Stamford Public Schools Board of Education, Facilities Management 888 Washington Boulevard, 3N Stamford, Connecticut 06901

RE: Capital Project (001313) Appropriation Request

District Wide Window AC Unit Project Additional Information

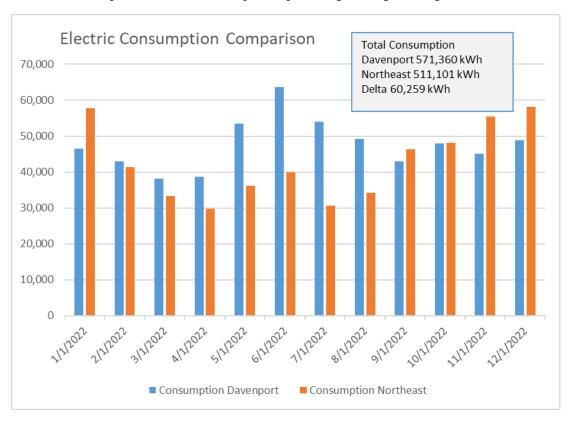
Benchmark an existing school that has existing window units and analyze the energy usage in the year prior to the window units being installed and the year after - normalize for any other energy savings projects in that school - like LED lighting. An example of a school to use might be Northeast School. This will help prove out the cost analysis for electricity usage that has been estimated previously.

Compare the costs of operating the schools with the window units vs the schools with central air conditioning.

All schools have LED retrofits. An energy usage analysis should normalize for weather to confirm year to year comparison has been corrected for degree day information.

Additionally, assumptions would need to be made for load factors, run times, etc. as well as installation costs. This is a more extensive analysis which will take additional time.

Below is a comparison table of electrical consumption at Northeast, which has window AC units, and Davenport, which has roof top units providing heating, cooling, and ventilation.
